STANDARD REQUEST FOR BID (Amendment)

Solicitation No N° de la demande	Amendment No N° de modification			
202200784/A	002

This amendment is raised to address the following:

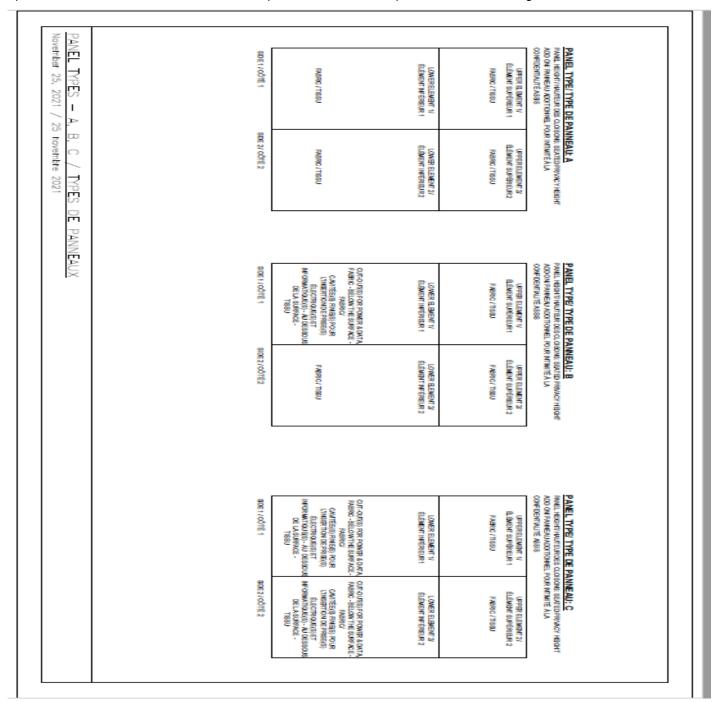
- Q7. Please clarify overhead requirement versus panel heights. A worksurface privacy height panel was indicated (42-49"), with this panel height a standard overhead mounted in the locations shown on plan would cover the worksurface mounted at standard height (29") rendering it unusable.

2) Under Attachment 1 to Annex C, delete panel matrices and replace with the following:

- A7. All worksurface privacy height panels are amended to seated privacy height. See uploaded drawings/floor plans
- Q8. Lines 4-7 appear to pertain to the private office furniture and the following questions are under the assumption they are to be a U-shape for 2 offices:
